STELLANTIS PARTS & SERVICES		Technical Service Bulletin (TSB) Air Bag Warning Lamp Illumination			
REFERENCE:	TSB: 10-001-23 REV. A GROUP 10 - Restraints	Date:	November 9, 2023	REVISION:	10-001-23
VEHICLES AFFECTED:	2015 - 2022 (B1) Jeep Renegade 2015 - 2018 (BU) Jeep Renegade 2019 - 2022 (BV) Jeep Renegade 2019 - 2022 (FD) Fiat 500X 2015 - 2018 (FB) Fiat 500X			MARKET APPLICABILITY: ☐ NA☒ MEA ☐ SA☒ IAP ☒ EE☐ CH	
CUSTOMER SYMPTOM:	Customers may experience a Malfunction Indicator Lamp (MIL) illumination. Upon further investigation the technician may find one or more of the following Diagnostic Trouble Codes (DTCs) has been set: • B0050-1D - Driver Front Buckle Switch - Out of Range (Active or Stored). • B0050-13 - Driver Front Buckle Switch - Circuit open (Active or Stored).				
CAUSE:	Micro vibrations between buckle and seat wiring connectors causing male and female terminal corrosion Fig. 1.

This bulletin supersedes Technical Service Bulletin (TSB) 10-001-23, date of issue August 25, 2023, which should be removed from your files. All revisions are highlighted with ****asterisks**** and include a new part number.

Fig. 1
Terminal Corrosion

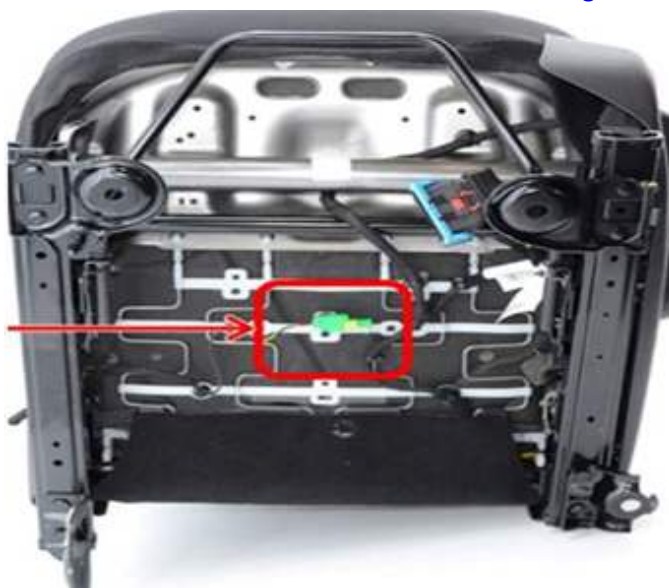
This bulletin involves replacing the inline seat connector.

3. Remove the old seat belt buckle connector.
4. Splice in the new in line connector. Refer to the detailed service procedures available in DealerConnect>Service Library under: Service Info> 10 - Restraints / Standard Procedure Supplemental Restraint System Wiring Repairs.
